HISTORIC AND DESIGN REVIEW COMMISSION

Agenda Item No: 27

HDRC CASE NO: 2015-320
ADDRESS: 1515 MISSION RD
LEGAL DESCRIPTION: NCB: 20 LOT: 22, 22B, 22C, 22D & 37 NCB: 24 P-100A NO LABEL# NO SERIAL# CR#2012-25965//2013-RESURVEY PER DEED 15737/22212 EX 10/5/2012
ZONING: IDZ H RIO-4
CITY COUNCIL DIST.: 3
DISTRICT: Mission Historic District
APPLICANT: White Conlee Builders, Ltd
OWNER: White Conlee Builders, Ltd
TYPE OF WORK: Construction of five, three and four story apartment buildings
REQUEST:

The applicant is requesting conceptual approval of site and building layout for the proposed MELA development. The applicant has proposed to construct five, three and four story residential apartment structures, a clubhouse, a commercial pet daycare and miscellaneous residential structures.

LAYOUT PATTERNS

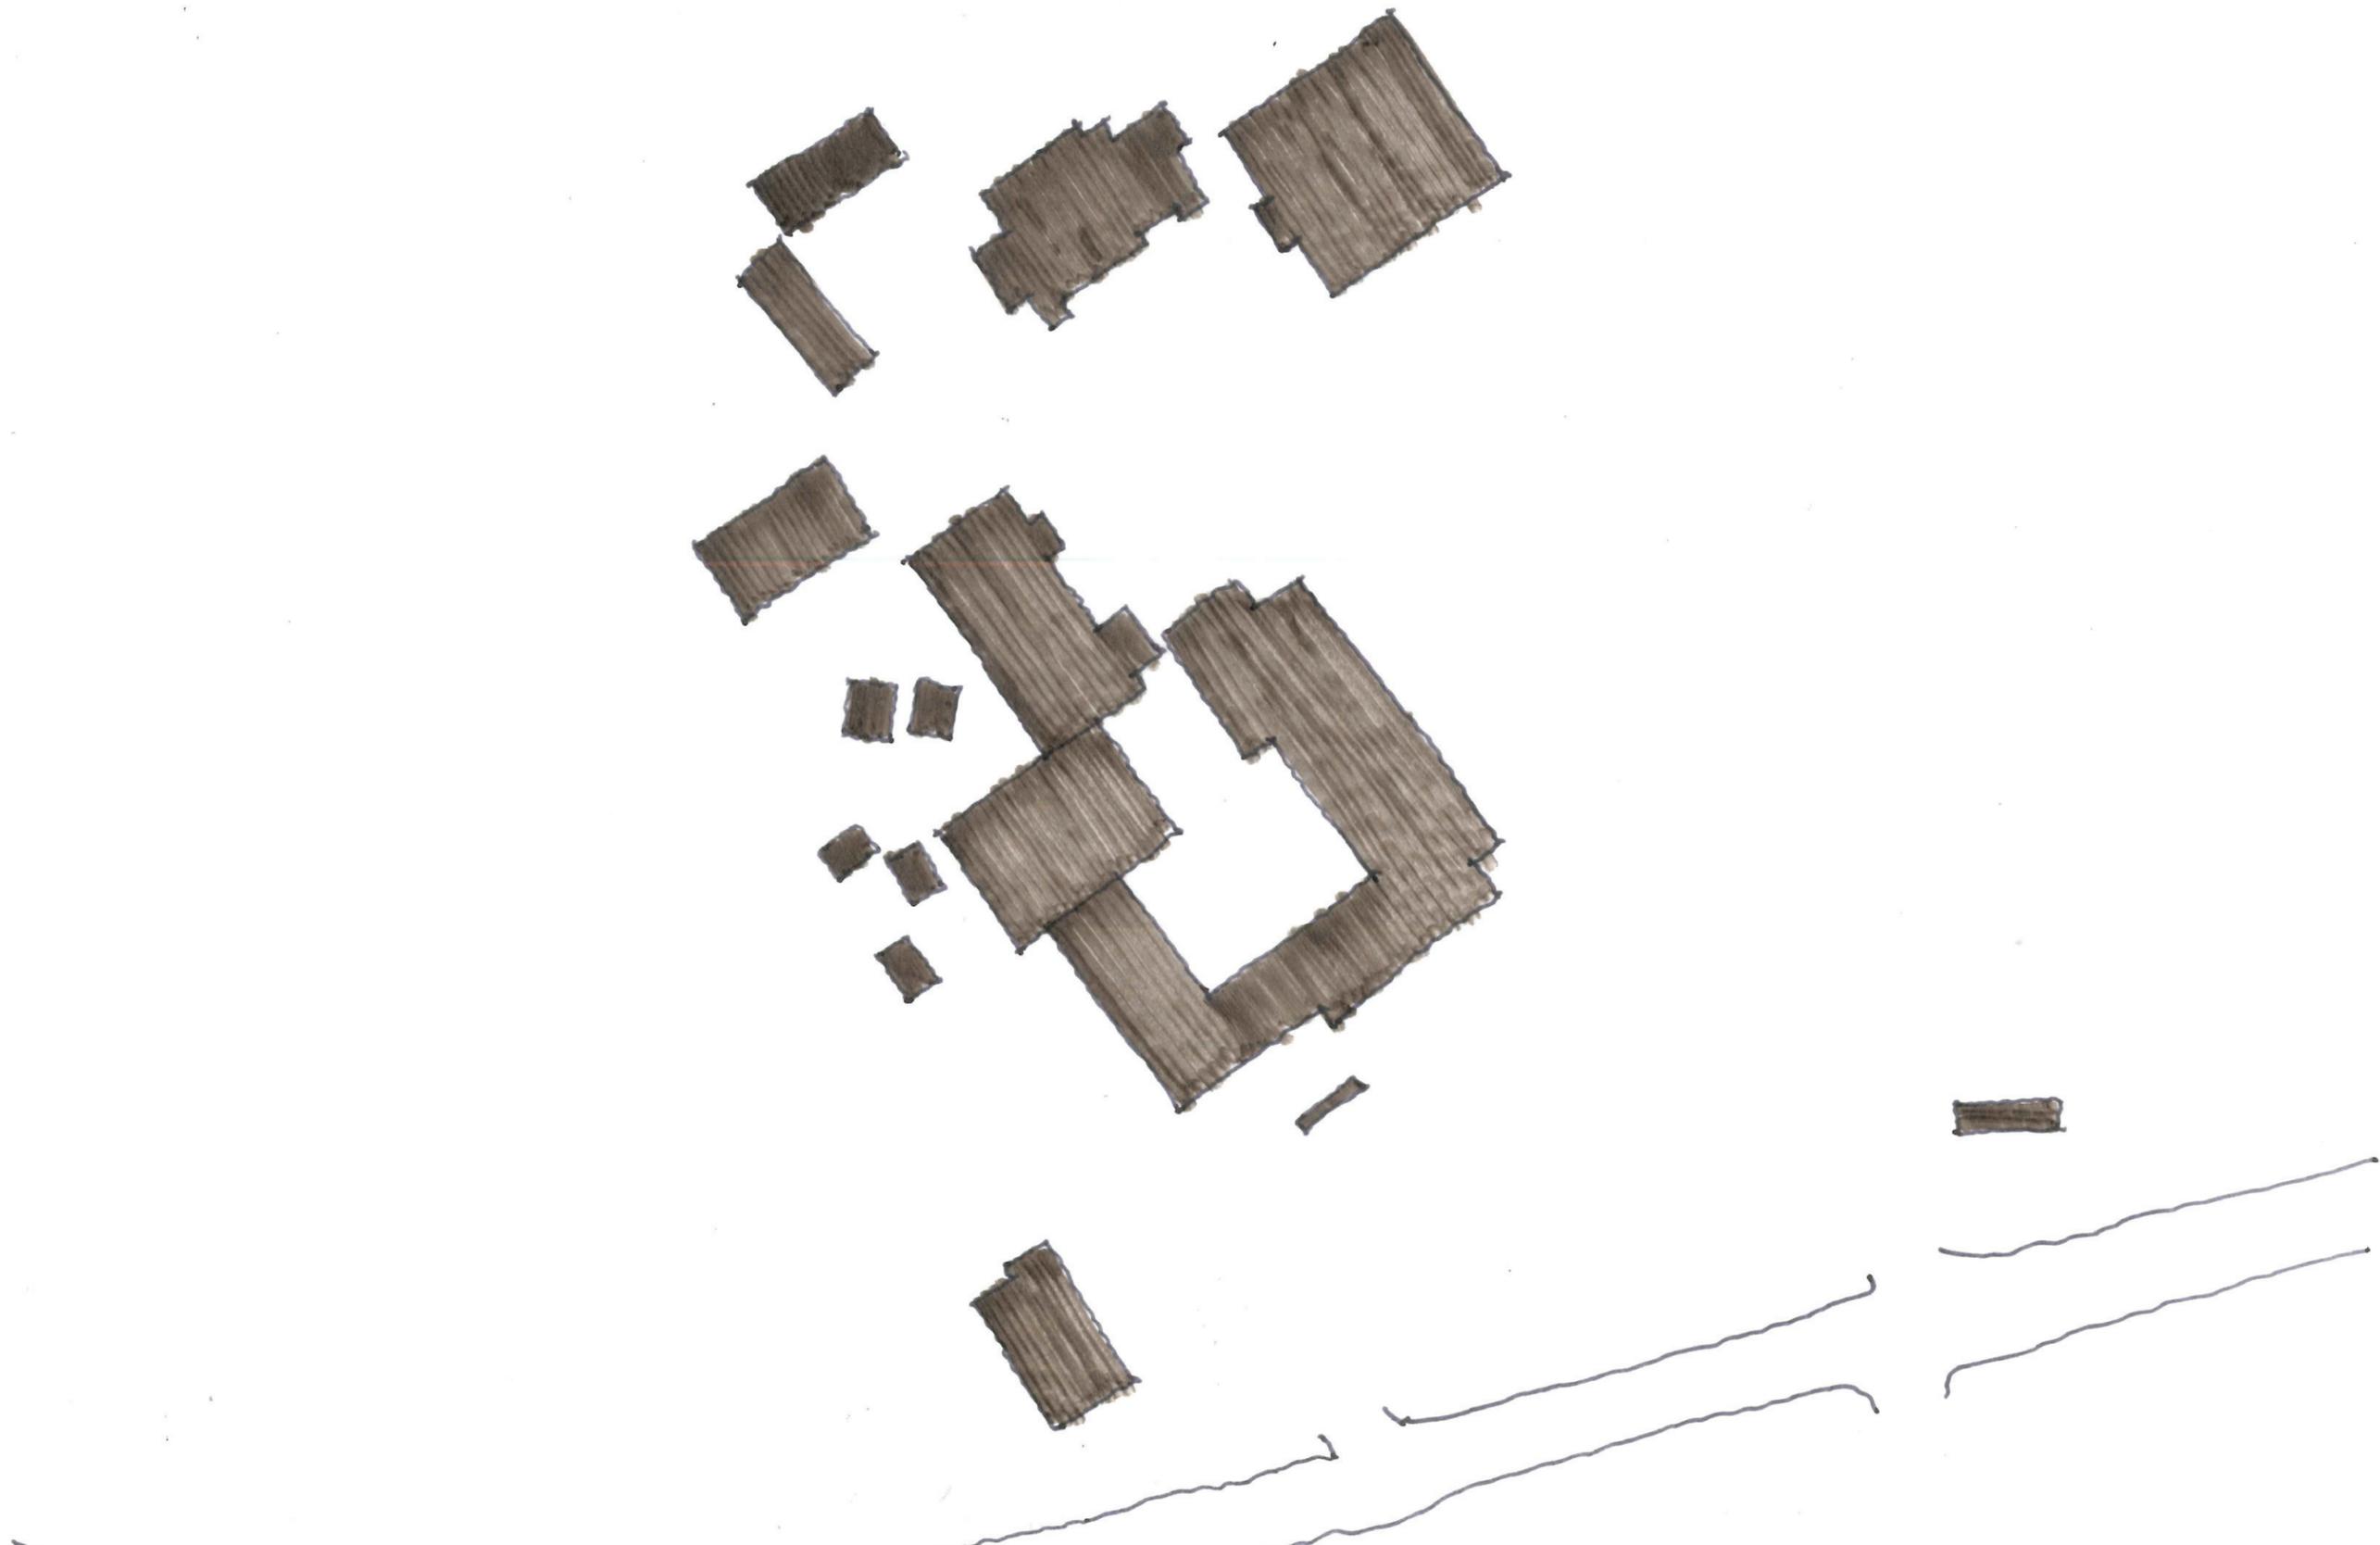
COMMENTS/CONCERNS: MC: NEW SITE PLAN ADDRESSES QUESTIONS PREVIOUSLY ASKED - ^{SANS} ~~AND~~ EASEMENT. HOW IS SITE DIVISION REFLECTED THROUGH DESIGN? MAIN CONCERN OVER SITE DESIGN - WHY NOT MAXIMIZE GOLF COURSE VIEWS - PROPOSAL PRESENTS A VERY NON URBAN DESIGN, OPPORTUNITY FOR A MAJOR IMPROVEMENT - DESIGN SHOULD INCLUDE URBAN GESTURES. MG: FIGURE-GROUND DIAGRAM FOR SITE IS APPROPRIATE. DESCRIPTIONS OF SITE CONSTRAINTS IS APPROPRIATE. CRITICAL EDGE IS DESIGN AT RIVER.
